### KNOXVILLE HISTORIC ZONING COMMISSION STAFF REPORT - CERTIFICATE OF APPROPRIATENESS APPLICATION

PROPERTY ADDRESS: 726 Deery St 37917

FILE NO.: 11-J-13-HZ

Replace one original window on the 1st-level front of the house and two originals on the north side to match the existing 2/2 double-hung configuration, but with wooden simulated divided light windows.

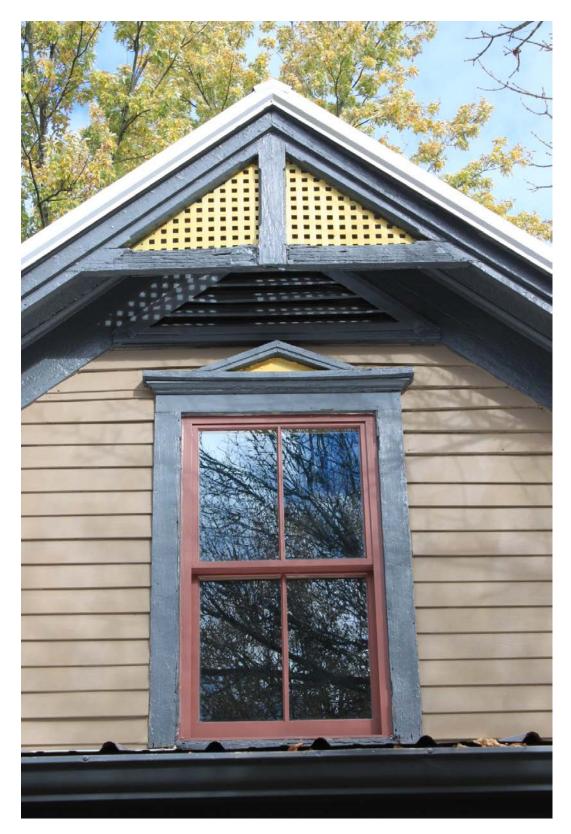
1. The three windows proposed to be replaced are the original 2/2 double-hung windows.

2. The two windows on the north side of the house exhibit multiple layers of paint and caulking. There are some small gaps between the sashes and frames that may cause some degree of difficulty in operation.

3. The windows do not exhibit signs of rot that are readily visible.

4. The window in the front gable of the house is a replacement window.

Staff recommends utilizing storm windows over [properly repaired windows in order to gain more energy savings.
